JAMES L. GRANT & ASSOCIATES, INC.  
environmental consulting and engineering  
8301 EAST PRENTICE AVENUE, SUITE 400  
ENGLEWOOD, COLORADO 80111  
(303) 779-0576 FAX (303) 721-1772

June 2, 1994

On behalf of Umetco Minerals, Inc., James L. Grant & Associates is submitting the attached information relative to Umetco's closure of the Heap Leach tailings pile at their Gas Hills, Wyoming facility. This information supplements our submittal dated April 12, 1994.

Mr. Ted Johnson  
Supplemental Information to Heap Tailings Closure  
Umetco Gas Hills Property  
June 2, 1994  
Page two

FIGURE 4.4

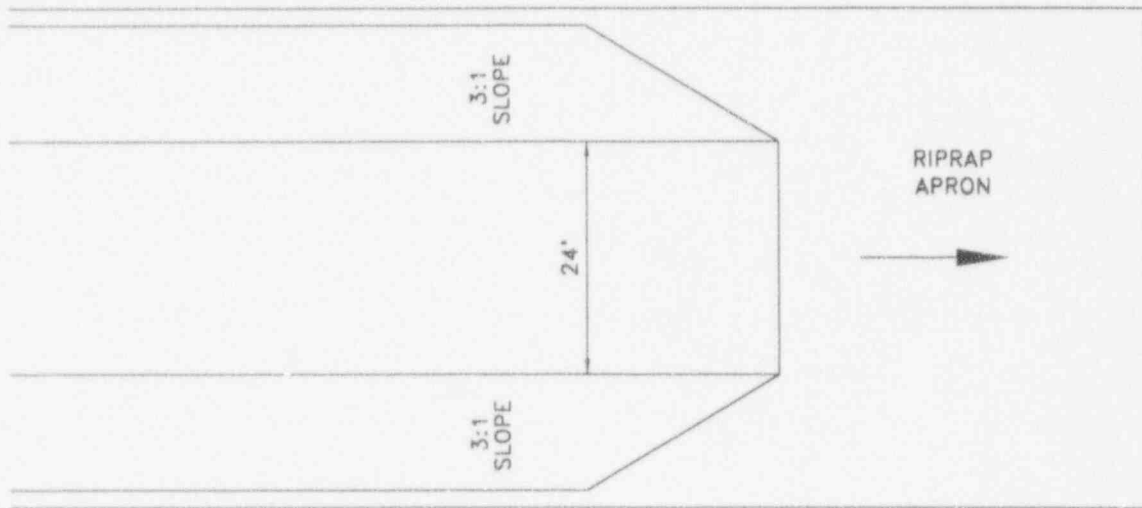
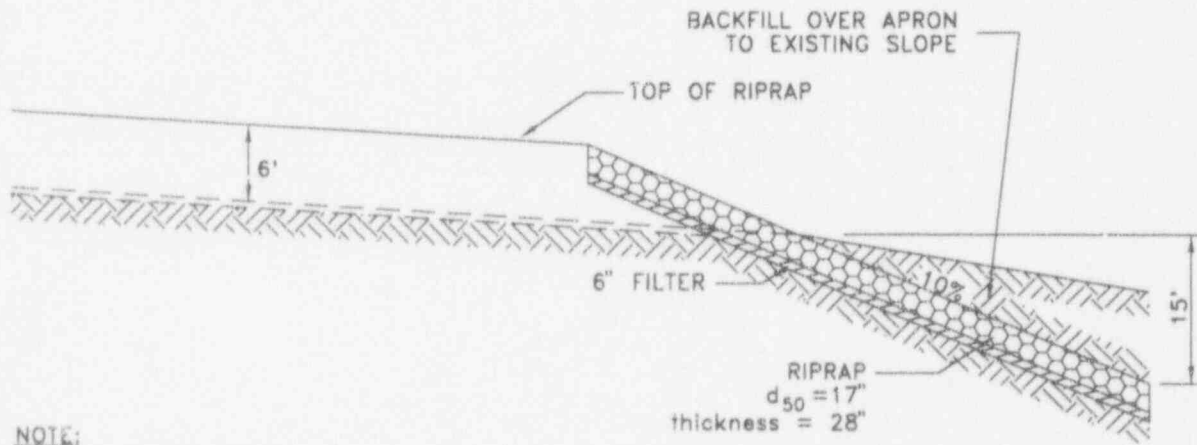
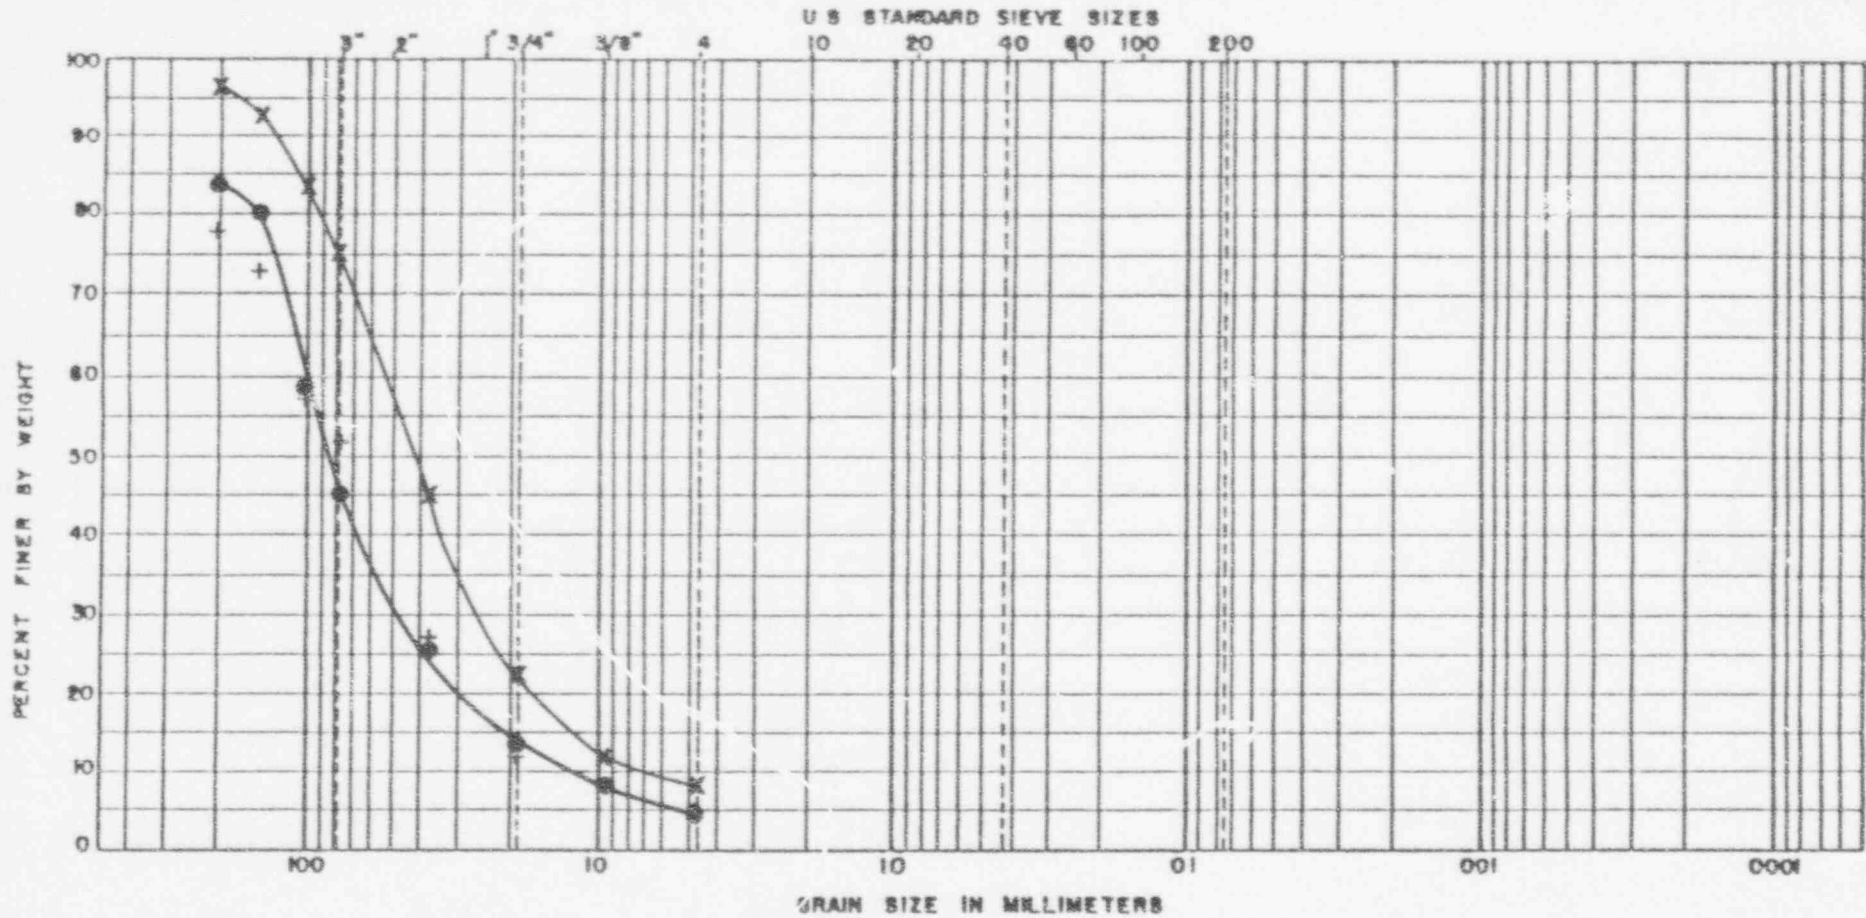
3. A redesign of the outlet to Channel C. Channel C will drain the Heap cover. Our original design incorporated a vertical riprap cutoff at the end of the channel extending below the maximum calculated depth of scour. The redesign provides a sloping apron that extends below the calculated scour depth. The design slope of the apron is 10%. A sketch depicting the revised design is included, as are calculations to support the design. The calculations include:

The uniform sand scour depth is conservative, since the site soils have some cohesion  
The scour predicted for the clayey sand is more representative of expected scour depth  
We will use a conservative design depth of 12 feet for the depth of the cutoff at the end of the  
channel

NOTE:  
CUTOFF IS 12" RIPRAP.
